Notice of Modification

Section 75W of the *Environmental Planning and Assessment Act 1979*

Development consent granted by the Minister for Planning on 13 October 1988 for the Spring Farm Quarry at 186 Macarthur Road, Lot 22 DP 833317 (formerly Lot 2 DP 625278 Vol 14788 Folio 34).

Figure 4
Extraction and
rehabilitation staging plan

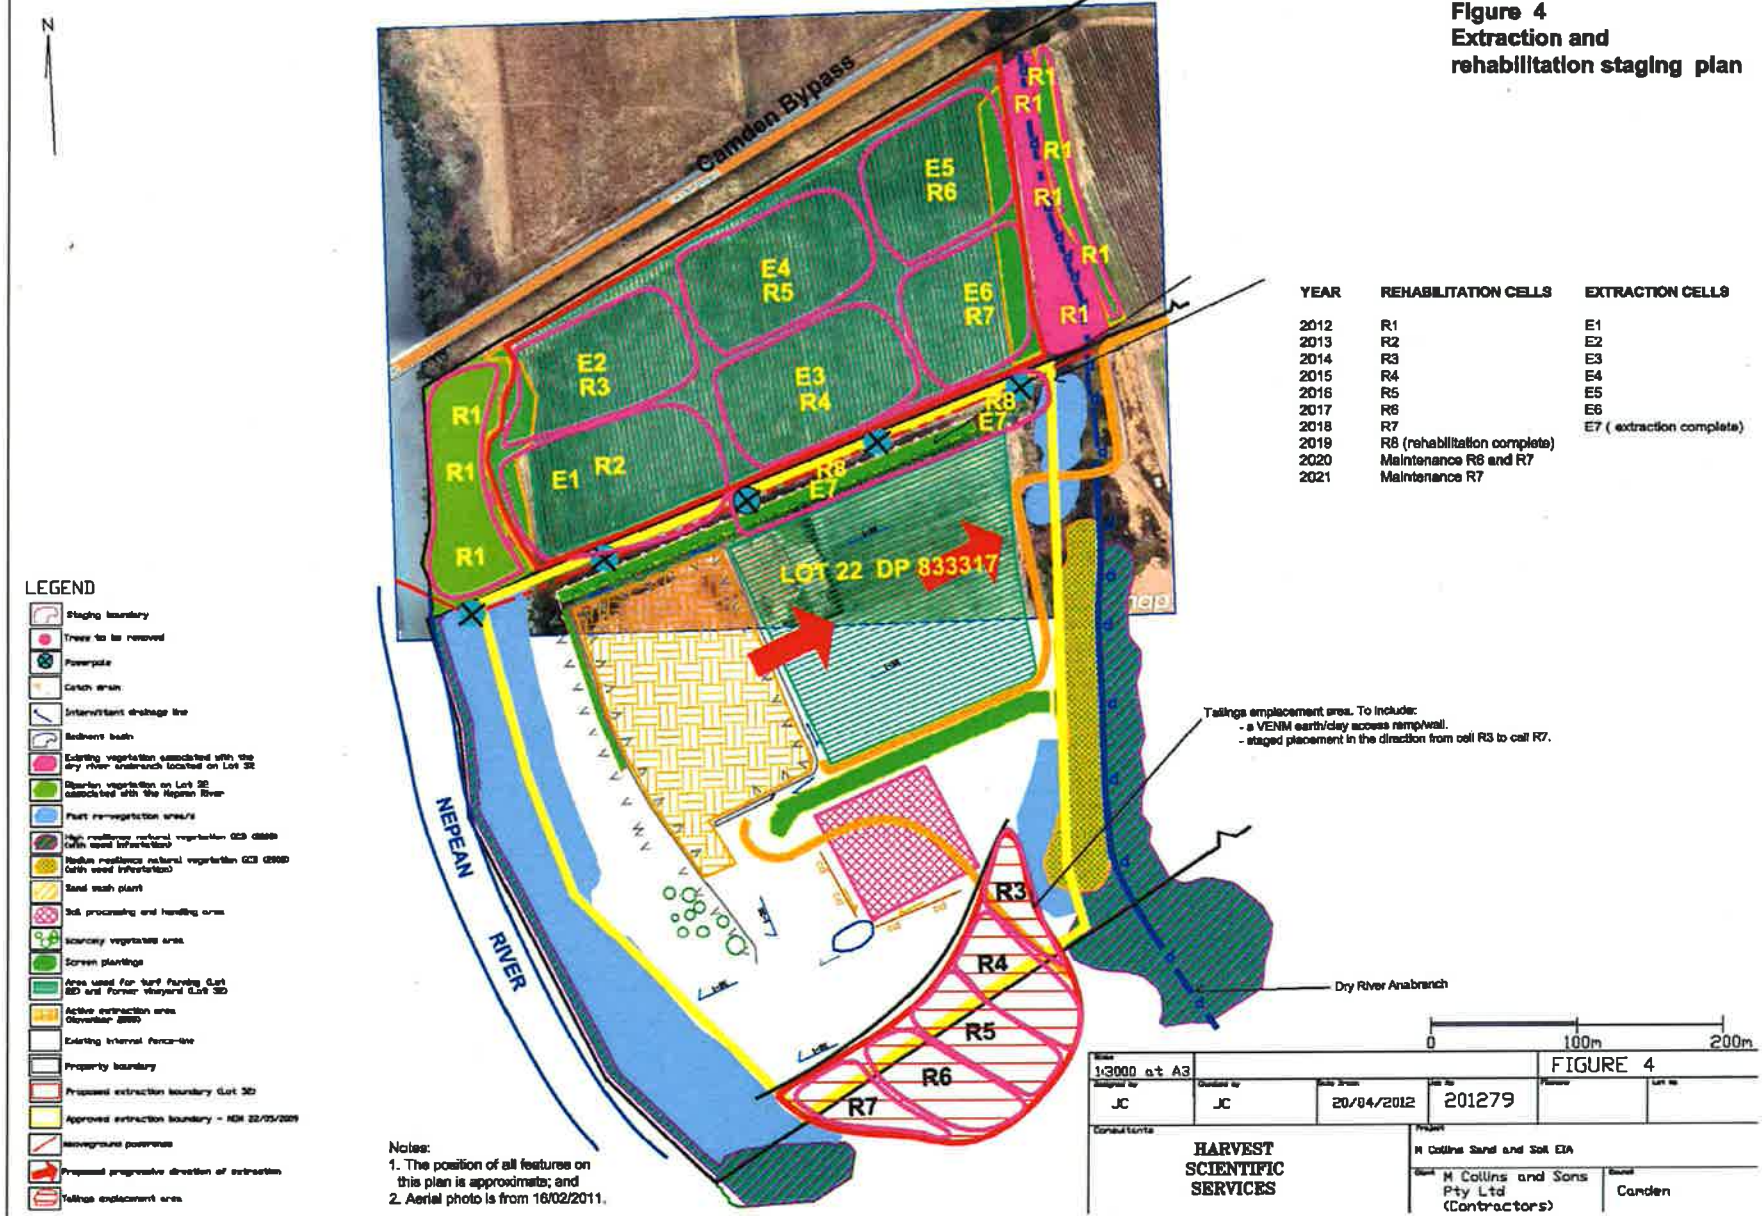
18. In Appendix 2, delete the figure and insert the following figures:

Proposed extraction and rehabilitation staging plan for Lot 32 and existing operations on Lot 22
